02 | Amendments to the Project Description

SECTION 02 AMENDMENTS TO THE PROJECT DESCRIPTION

This Section of the Alpha Coal Project Supplementary Environmental Impact Statement (SEIS) provides a description of the key changes made to both the proposed coal mine and railway corridor Project Descriptions since the Environmental Impact Statement (EIS) was issued in November 2010. Environmental impacts resulting from these changes are addressed within the SEIS. Coal mine and railway corridor Project changes are discussed in further detail in the sub-sections that follow.

Figure 2-1 Sketch of typical In-Pit Crushing and Conveying system

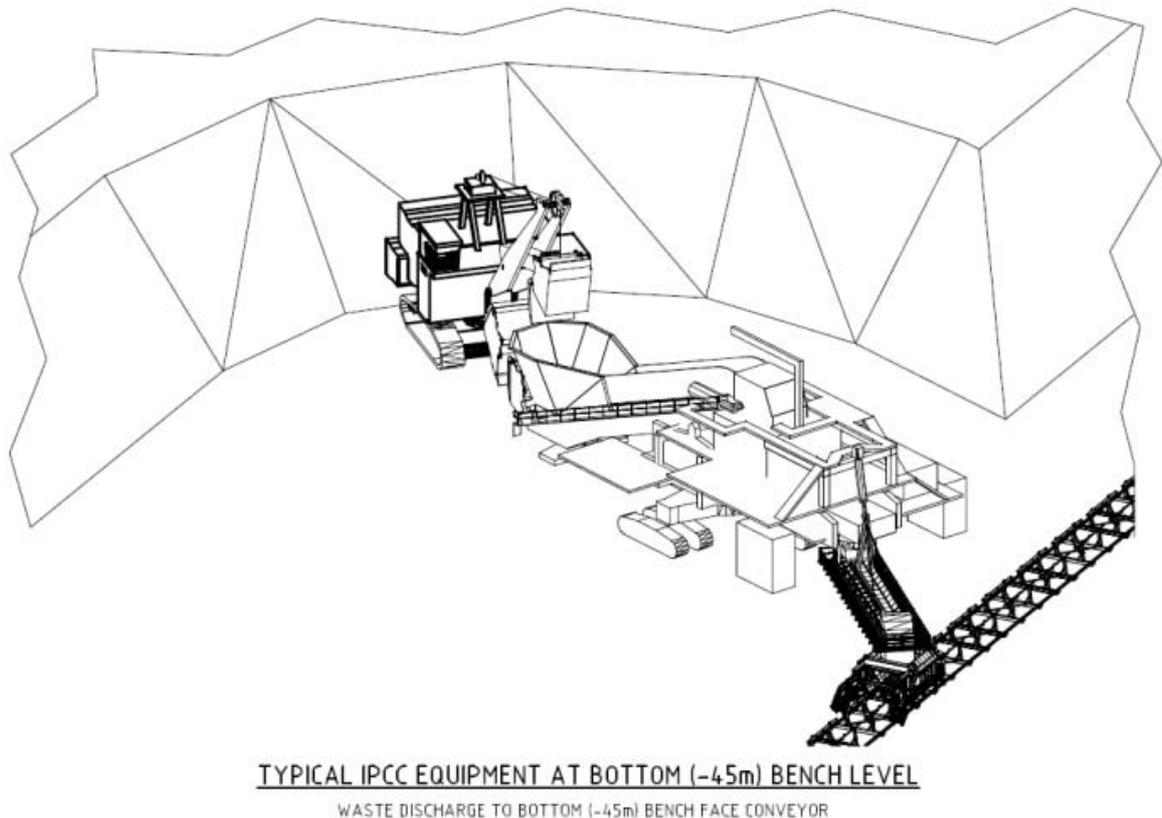
The mining method presented in the EIS was a conventional dragline and truck-shovel pre-strip operation with coal haulage by bottom-dump coal haulers. Following further review of the proposed mining methods, two In-Pit Crushing and Conveying (IPCC) systems have been included in the revised mine plan. A functional description of the IPCC system proposed can be found in Volume 2, Appendix H and a figure showing typical IPCC equipment can be seen on Figure 2-1 below.

Through the introduction of IPCC, combined with a reduction in mine waste as discussed in Section 2.1.1.3 below, the mining operation at its peak will require 65 less 360 tonne (t) rear-dump trucks to haul overburden material.

Figure: 2-2

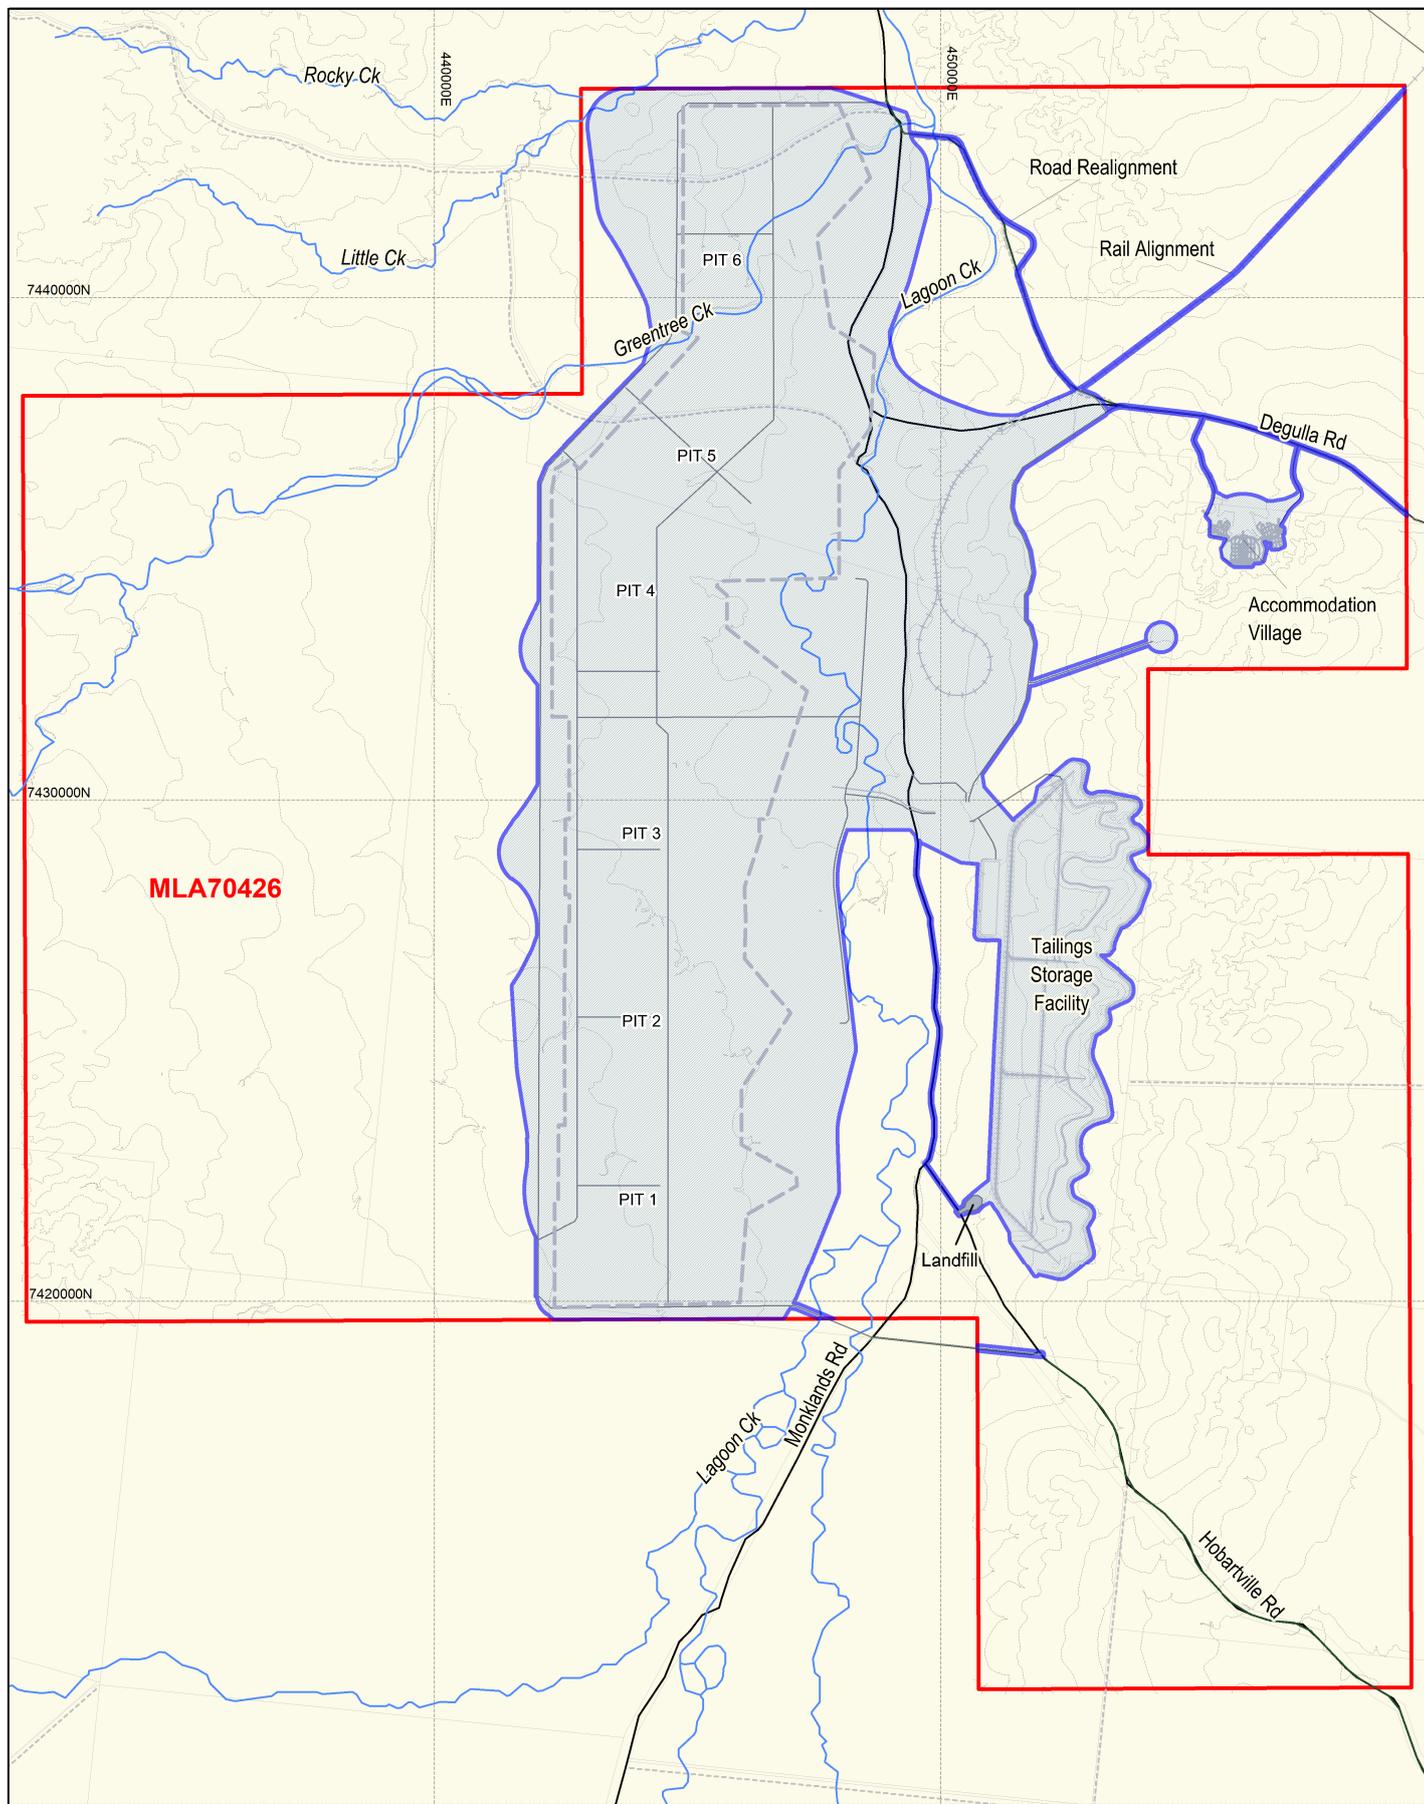
The changes in mining methods and equipment, in conjunction with the increased yield at the CHPP, have resulted in a reduction to the 30-year mining footprint (see Figure 2-2). When compared to the Project footprint presented in the EIS, the current footprint's disturbance area is 20,680 hectares (ha) or 8% less (see Figure 2-3). This reduction in disturbance area translates into less vegetation clearance overall and reduced surface water diversions. Table 2-2 provides a comparative summary of vegetation disturbance for the EIS and SEIS disturbance areas.

Figure: 2-4

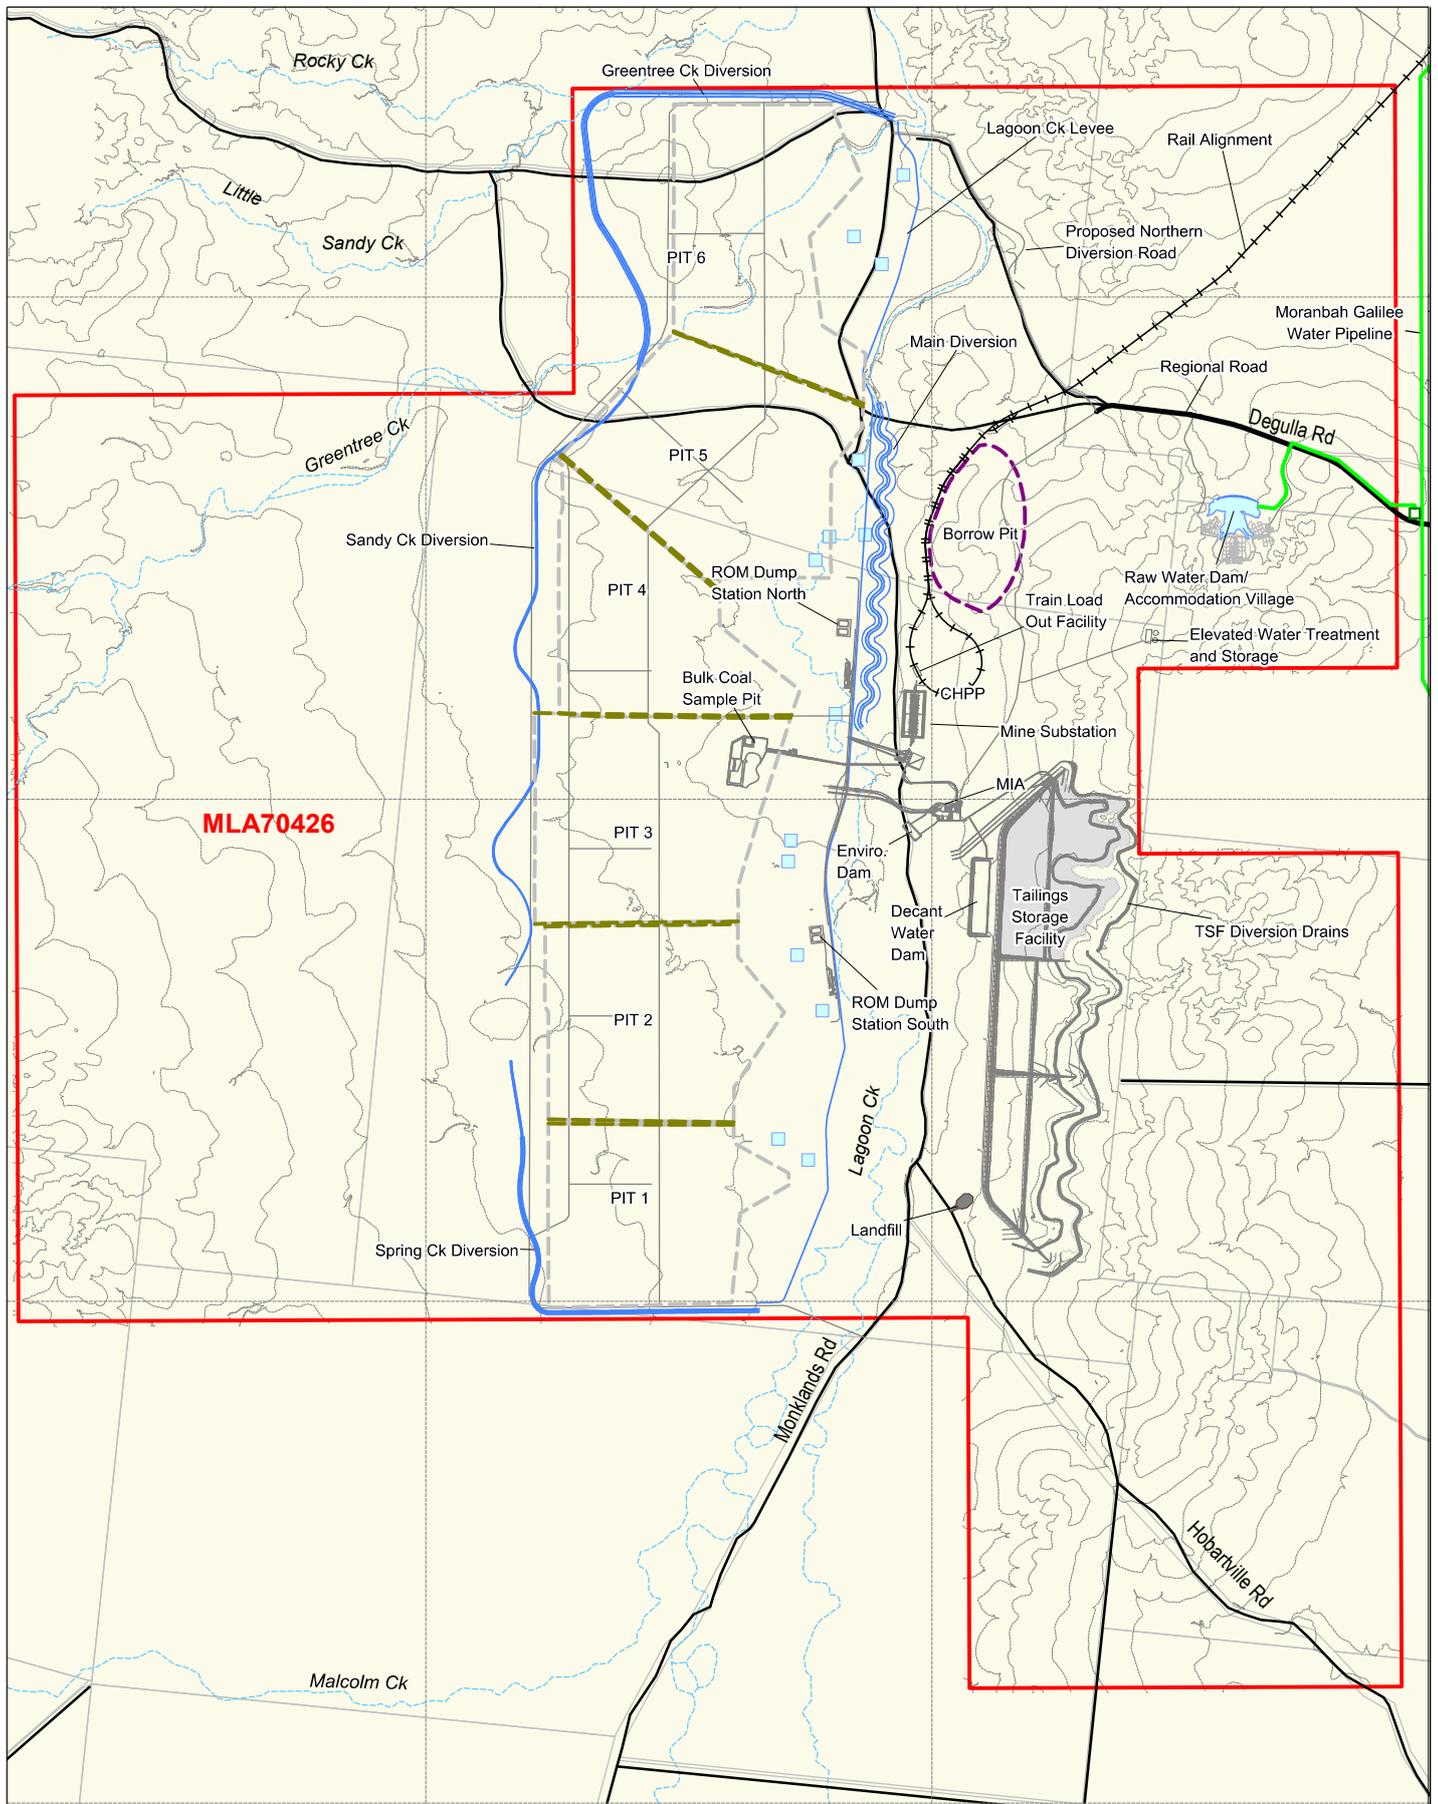
In the EIS only one temporary land bridge was proposed as part of the mine design. Under the current SEIS mine design there will be five permanent land bridges as shown on Figure 2-4 above. The permanent land bridges are required to allow for uninterrupted conveyor access and improved dragline and trucking utilisation.

The new box cut location also allows for early introduction of dragline operations, thus allowing truck numbers for waste haulage to be reduced / managed from the outset of mine operations. See Figure 2-4 for details of the new box cut location.

Run of Mine (ROM) locations have shifted in order to accommodate changes to the Mine Plan as shown on Figure 2-4 above.

The CHPP and transfer infrastructure to the Train Load Out (TLO) have been relocated approximately 500 m to the south-west of their original location due to changes made to the alignment of the rail loop as shown on Figure 2-4 above.

The revised MIA building layout and the building layout of the proposed LIA can be found in the Project Wide Project Description in Volume 2, Appendix C, Section 3. The location of both the MIA and LIA areas are shown on Figure 2-4.

Both the Potable Water Treatment Plant (PWTP) and Sewage Treatment Plant (STP) have been relocated as shown on Figure 2-4. The PWTP is now to be located on the ridge between the MIA and the accommodation village, which is in close proximity to the new raw water dam. The STP position will be closer to the main sewage source (the accommodation village), while still being down gradient from it. This will enable potable water to be supplied to all the large usage sites under gravity and a relatively short pump from the raw water dam to the PWTP. The main drivers behind the relocation of the STP and PWTP were the changes in location of the main load centres (LIA and accommodation village (Section 2.1.4.4)).

The EIS proposed Hobartville Road as the main site access road. This is now changed to Degulla Road, with Hobartville Road functioning as a secondary access route (refer to Figure 2.4).

The EIS proposed the raw water dam to be adjacent to the rail loop. The raw water dam will now be co-located with the accommodation village as shown on Figure 2-4. This location change was made so that the raw water dam would be in close proximity to the incoming bulk water supply pipeline, whilst at the same time providing an aesthetic point of note (water feature) to the accommodation village residents.

A number of changes have been made to on-site roads shown on Figure 2-4, of which the main changes are detailed below.

The Lagoon Creek diversion floodplain presented in the EIS has been widened following discussions with the regulators and after a compromise with the Project mining team. The revised Lagoon Creek diversion is presented on Figure 2-4. As part of the diversion changes, some floodplain was gained from the mining operation after trade-off exercises were conducted, taking into account both the economics of spoil dump arrangements versus excavation of the diversion's high flow channel, and approvability concerns/environmental benefits.

Spring Creek and Sandy Creek diversions are now aligned to match the final end of mine life highwall alignment as shown on Figure 2-4. The final highwall position generally moved eastwards from that presented in the EIS following mine plan revisions. The revised diversion alignments optimise the use of natural gradients, which results in a reduction in diversion length and earthworks and provide improved surface water capture for the protection of the mining area.
